# CITY OF ALBUQUERQUE

**RE: Volcano Cliffs Arsenic Treatment Facility**  
**6600 81<sup>st</sup> St NW**  
**Grading and Drainage Plan**  
**Engineer's Stamp Date: 02/03/2026**  
**Hydrology File: E09D001**  
**Case # HYDR-2026-00042**

Based upon the information provided in your submittal received 02/03/2026, the Grading & Drainage Plans are **not** approved for Grading Permit or Building Permit. The following comments need to be addressed for approval of the above referenced project:

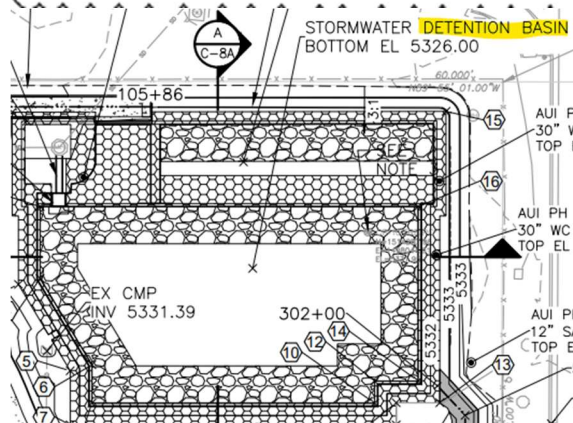
1. Please provide the FIRM Map and floodplain note with effective date.
2. Please provide the legal description of the property.
3. Pg 6 of 6 – Correct the sentence: Should this be a Detention Pond?

> CFS. FINALLY, THE PROPOSED **ETENTION** POND BOTTOM ELEVATION IS AT  
> 5326.00 FT, WHICH IS APPROXIMATELY 1 FT BELOW THE ORIFICE INVERT  
> ELEVATION AND PROVIDES APPROXIMATELY 7,087 CF OF STORAGE WHICH  
> EXCEEDS THE REQUIRED SWQV.

**TITLE: VOLCANO CLIFFS ARSENIC TREATMENT FACILITY AND PUMP STATION UPGRADES GRADING PLAN**

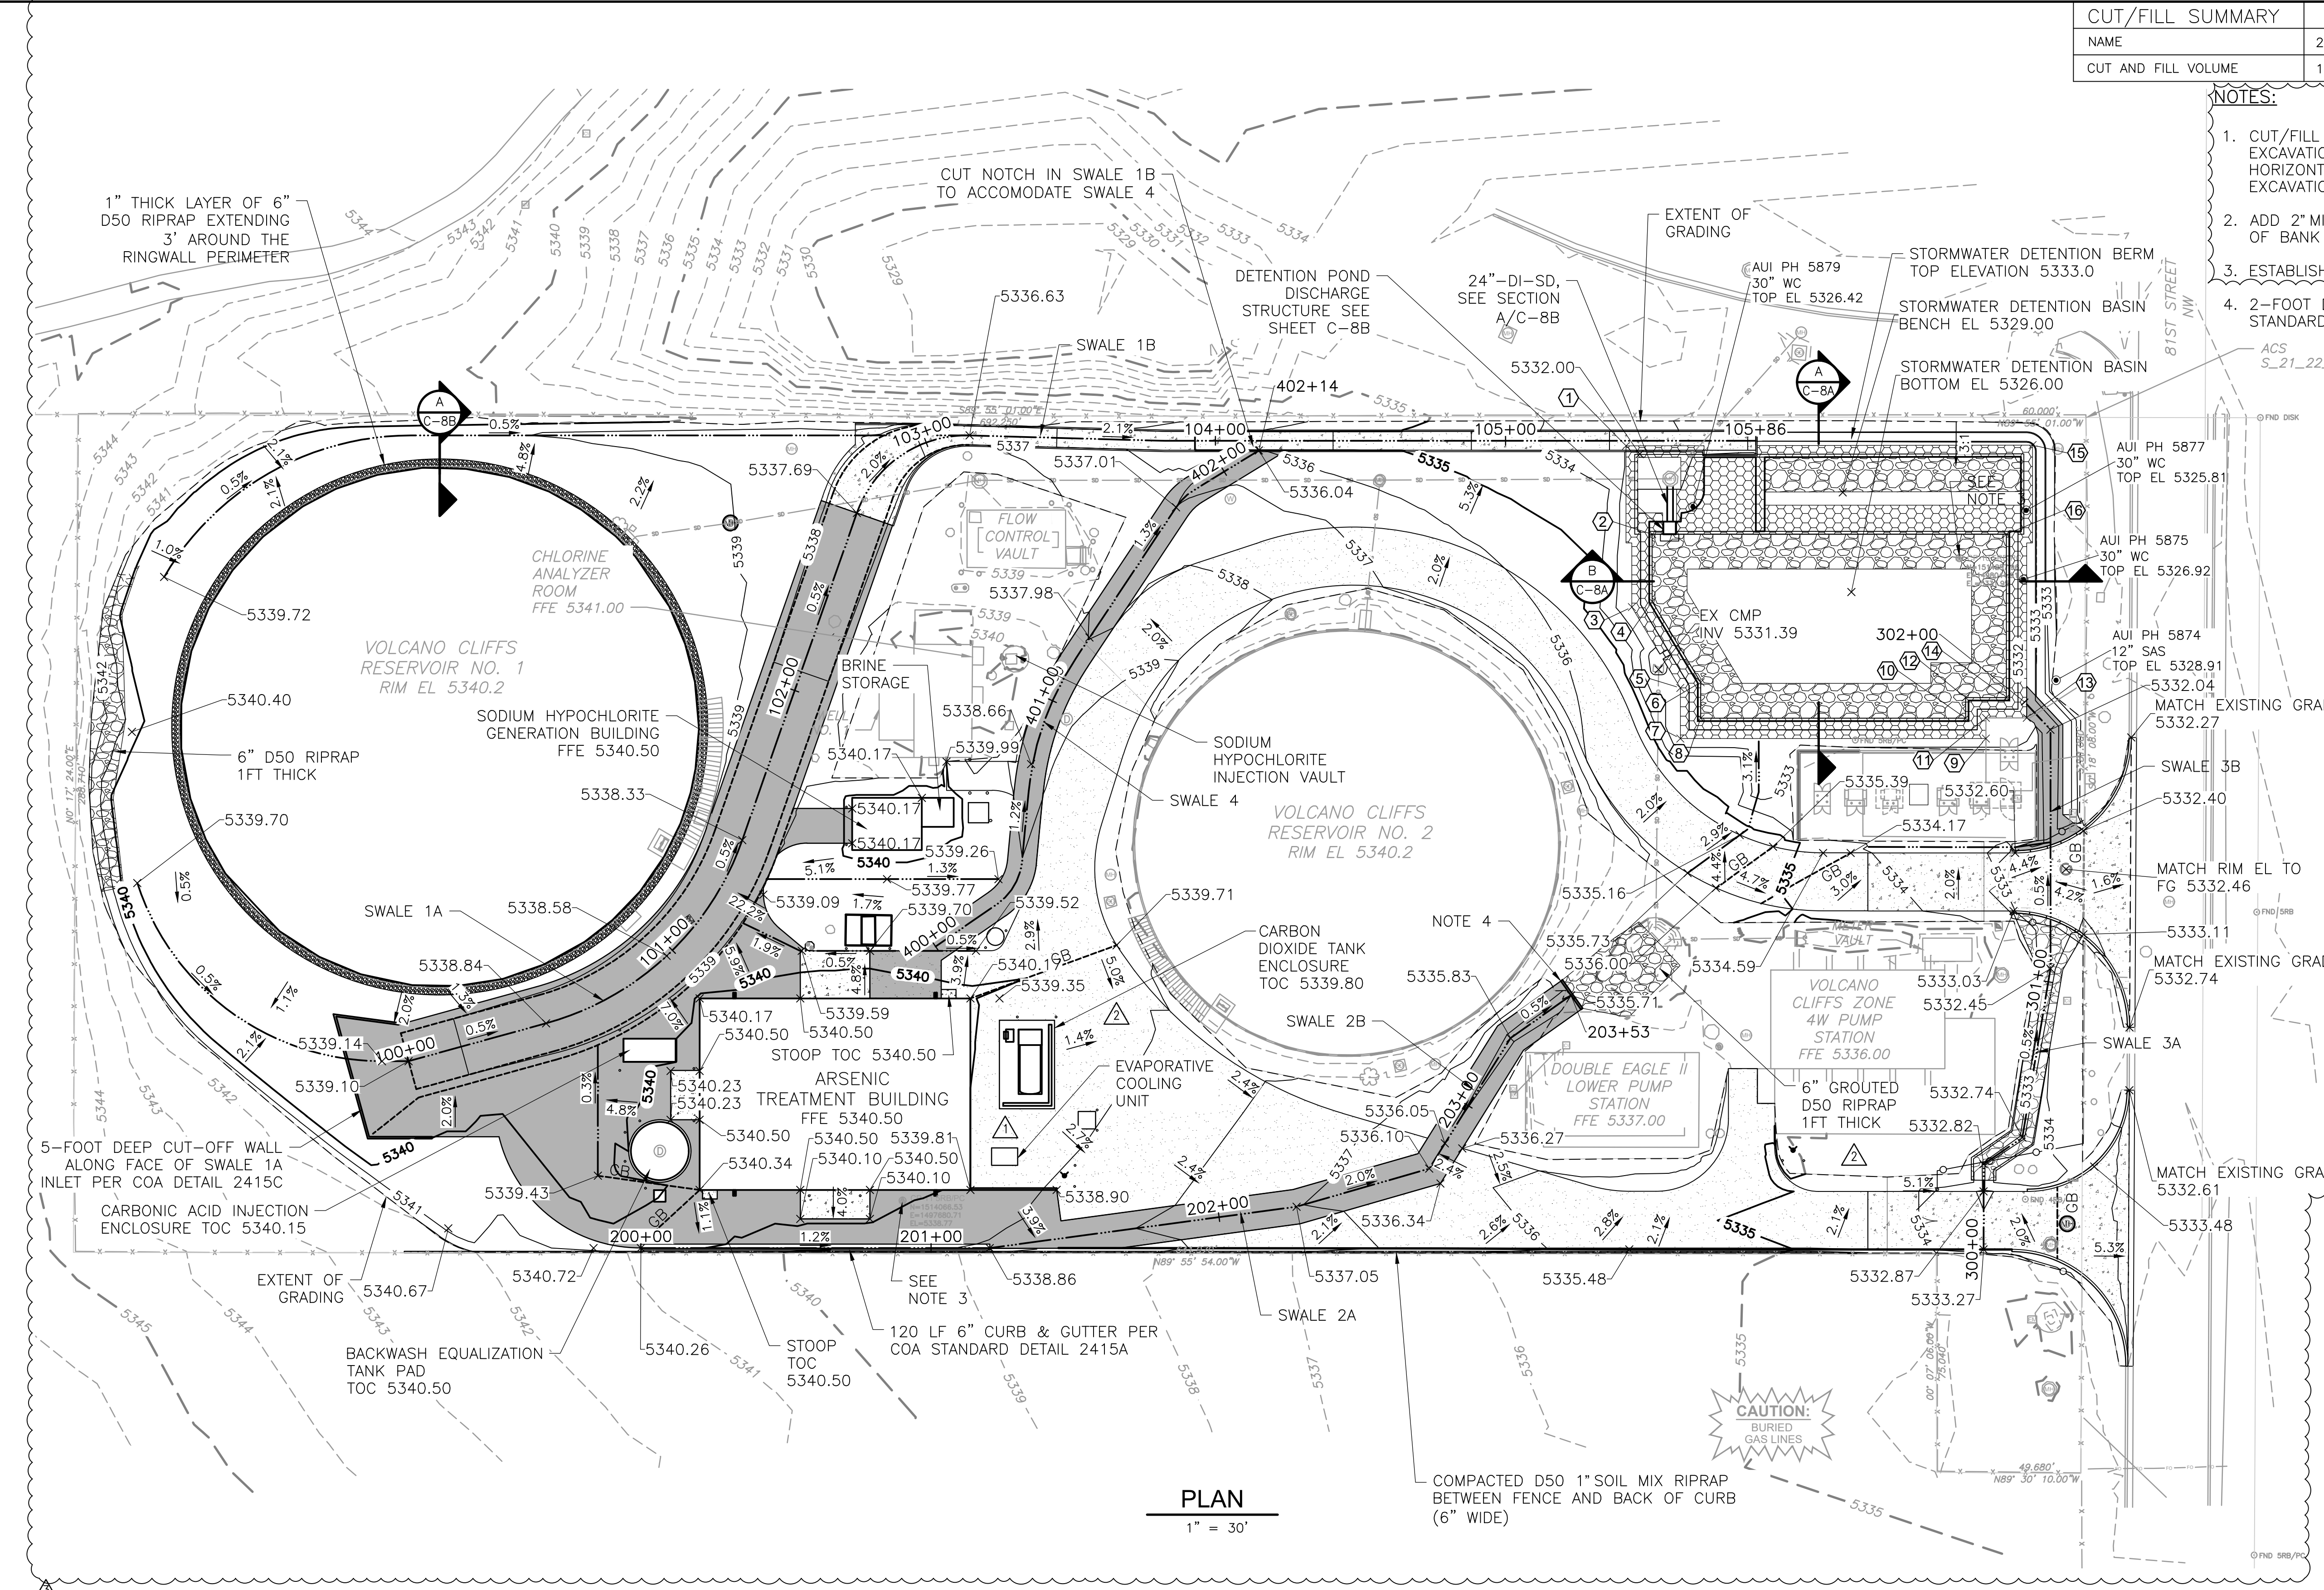
4. Wall Height - Provide the existing and proposed grades on both sides of the proposed cut-off wall. Provide the top of wall elevations.
5. Show the elevation of the Evaporative Cooling Unit to ensure proper elevation.
